BID PACKAGE 02 – ADDENDUM 06

Re: Wilma P Mankiller Health Center Expansion

From: James R Childers Architect, Inc.
45 South 4th Street
Fort Smith, Arkansas 72901

Item 01 See attached Substitution Request for Operable Partition.

Panel Hinge

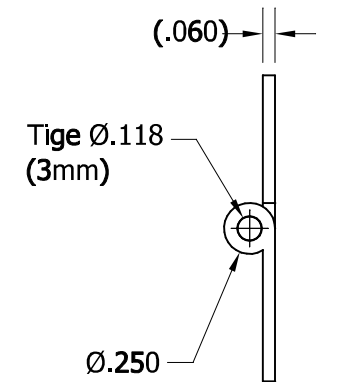
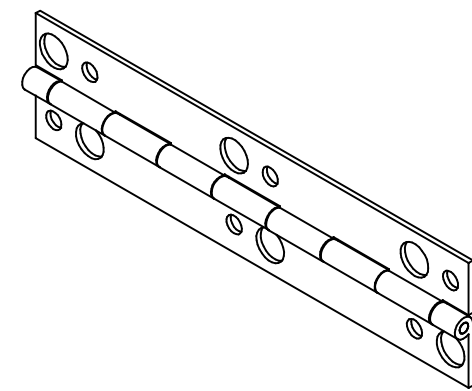
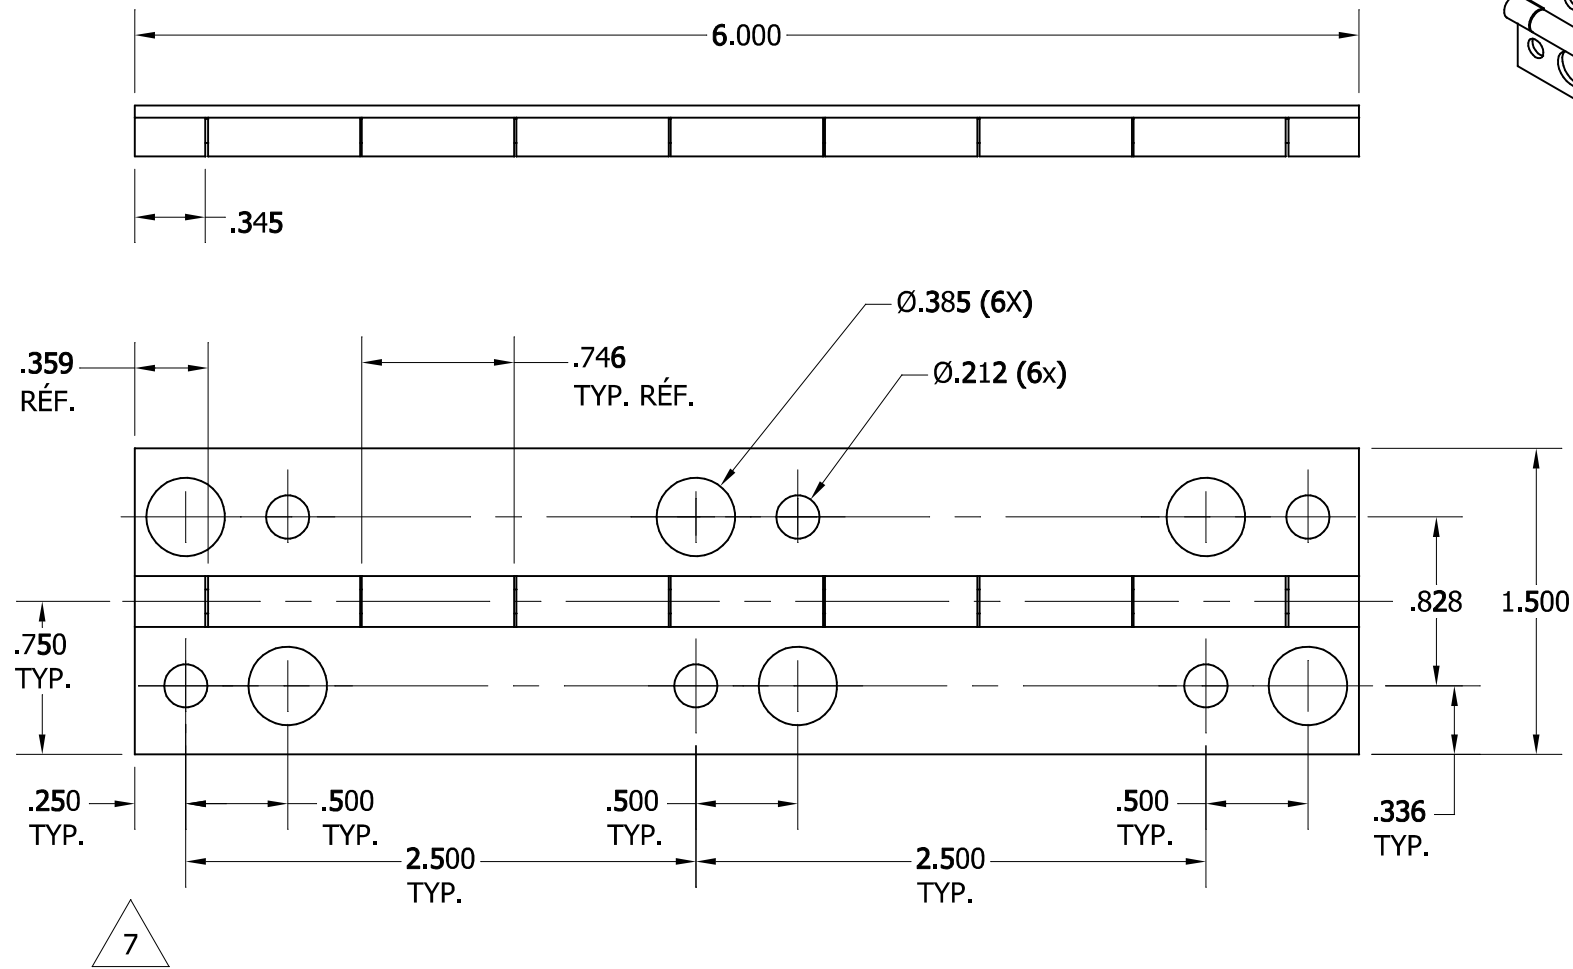
Differences between proposed substitution and specified product: Piano hinges projecting 1/4" from panel face

Contractor / Subcontractor to coordinate necessary opening / clearance requirements per manufacturer's recommendations.
Provide required adjustments for Architect's review and approval prior to installation.
